**Addendum Number:** 01

**Addendum Issue Date:** February 1, 2021

**Project Name:** CMH Ortho Clinic Addition and Renovation

**Project Number:** 0200707.00

E2.1

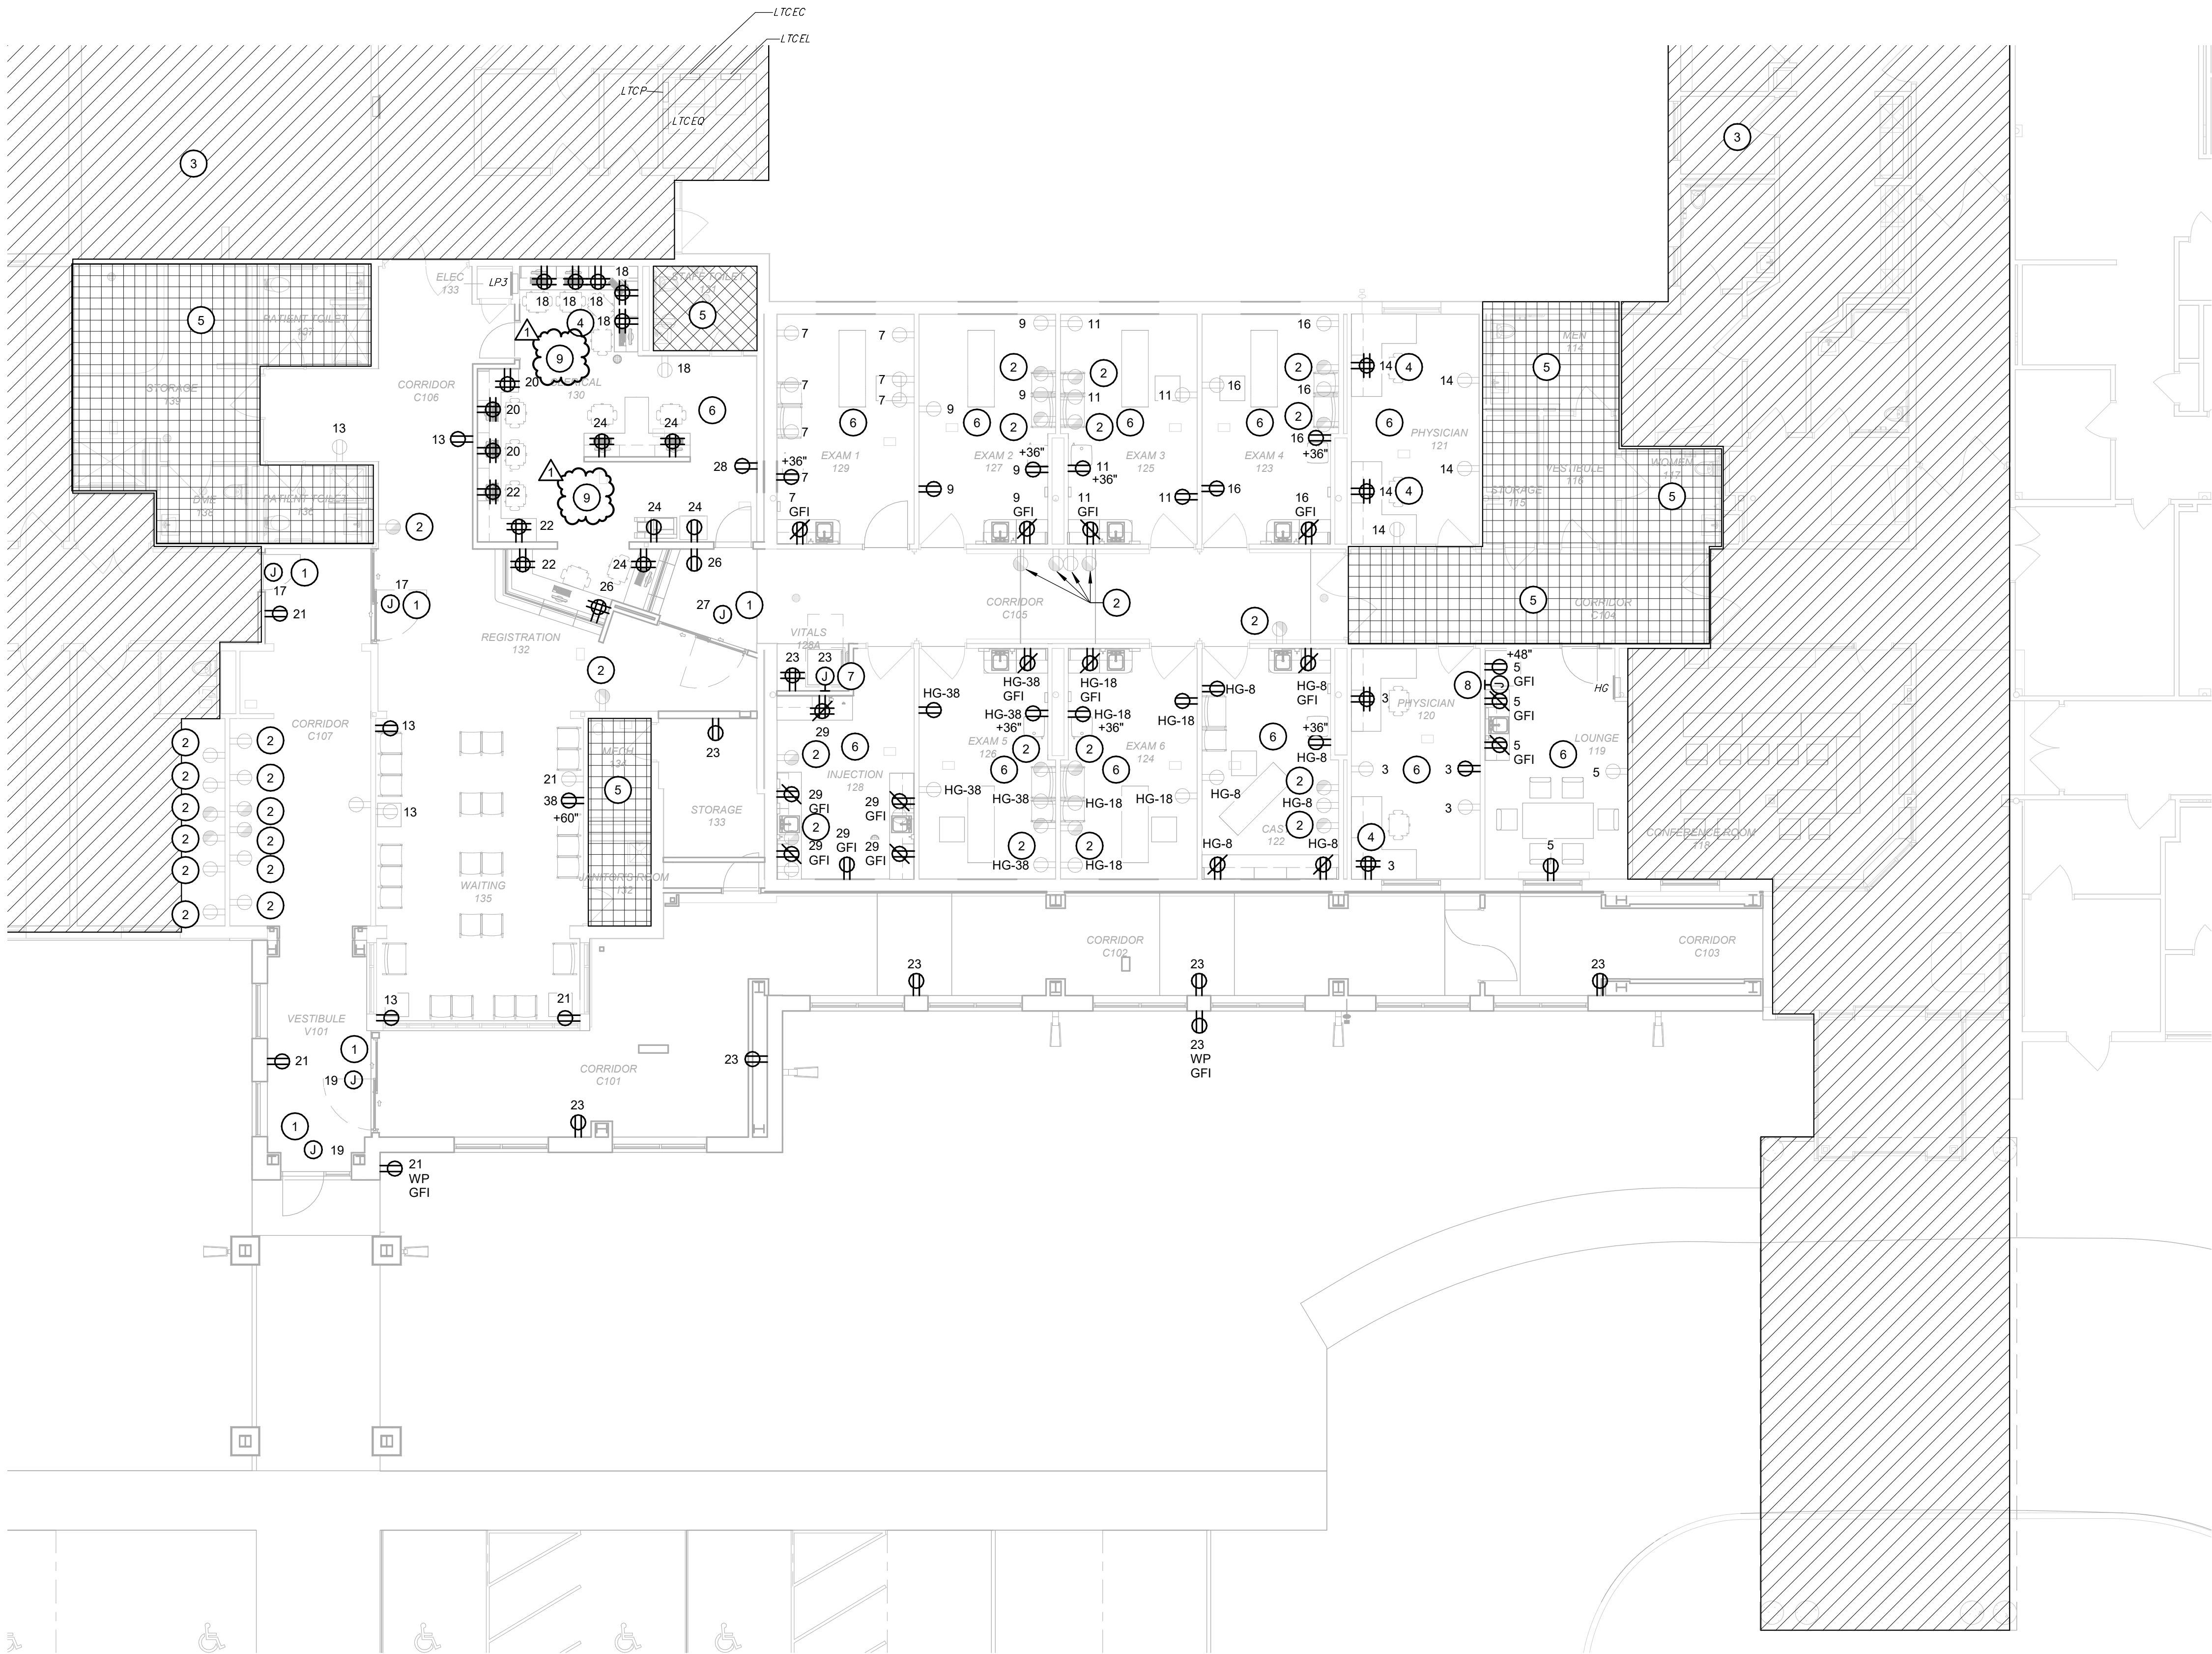
13. Sheet E2.1 – FIRST FLOOR POWER PLAN

- a. ADD Keynote 9 to the clerical area and to this list of Keynotes. See the attached reissued sheet.

E3.1

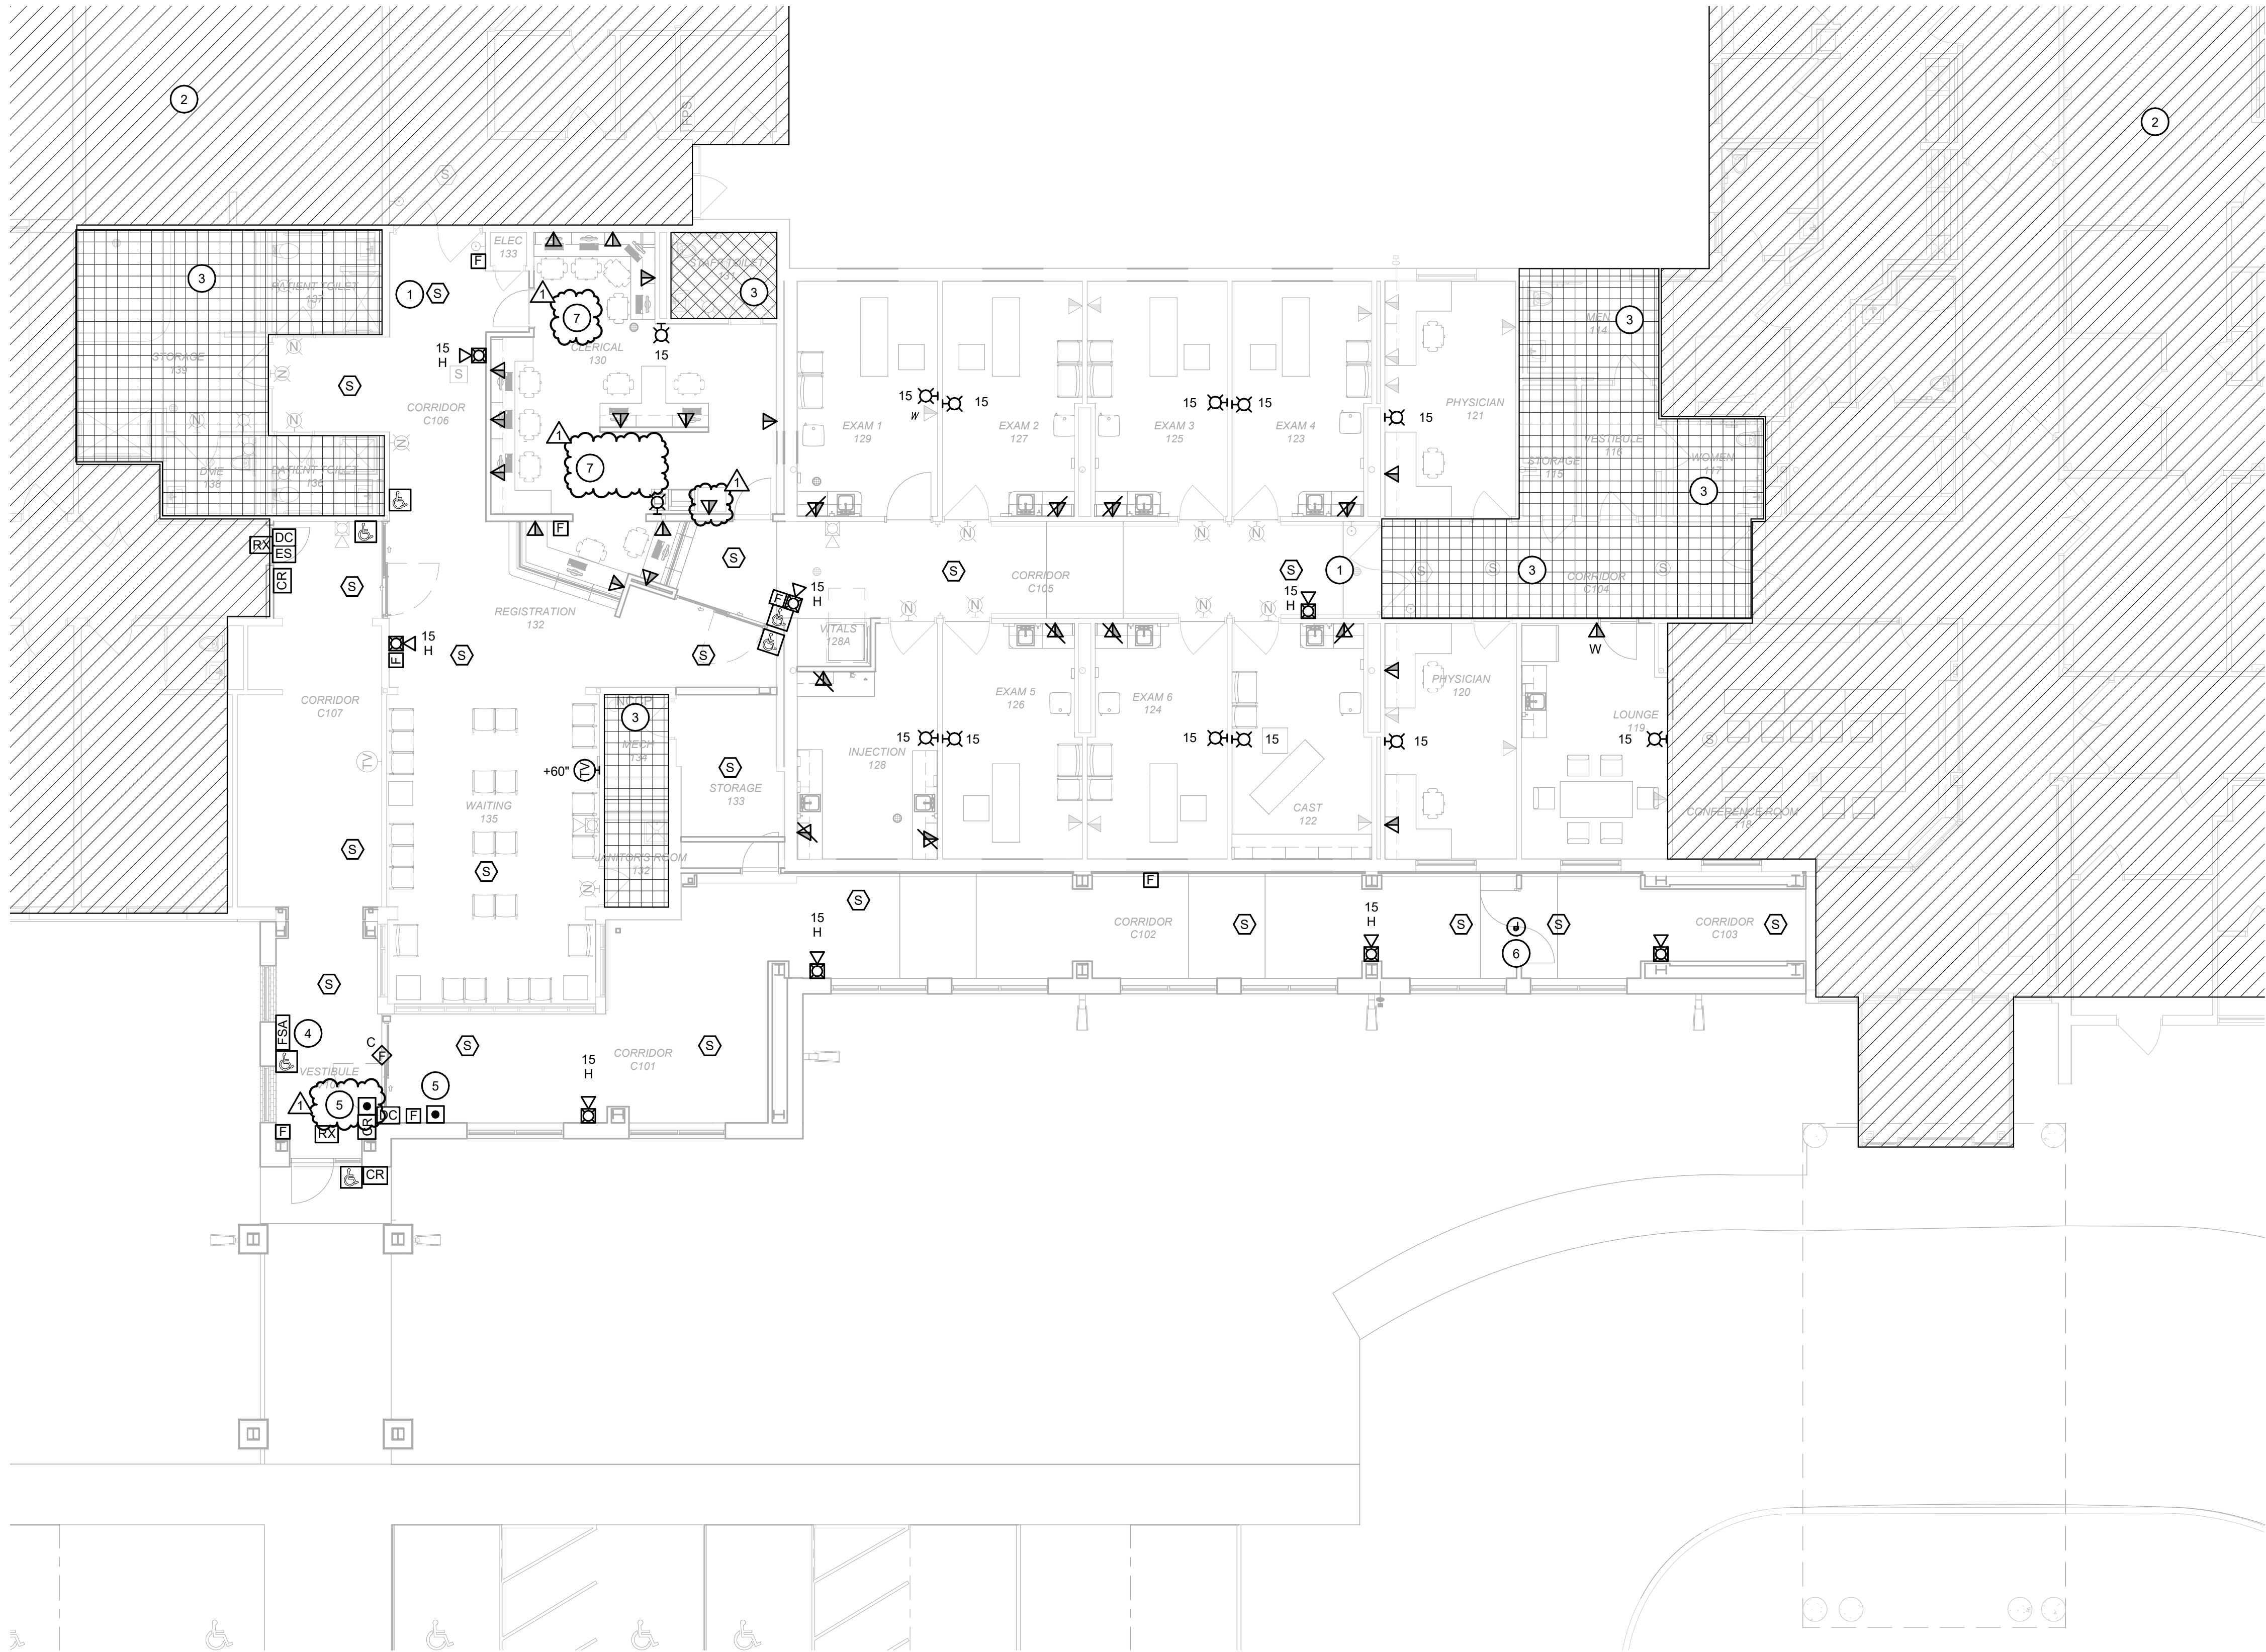
14. Sheet E3.1 – FIRST FLOOR SYSTEMS PLAN

- a. ADD keynote 7 to the clerical area and to the list of Keynotes. See the attached reissued sheet.
- b. ADD Push button control to enter C101. See the attached reissued sheet.
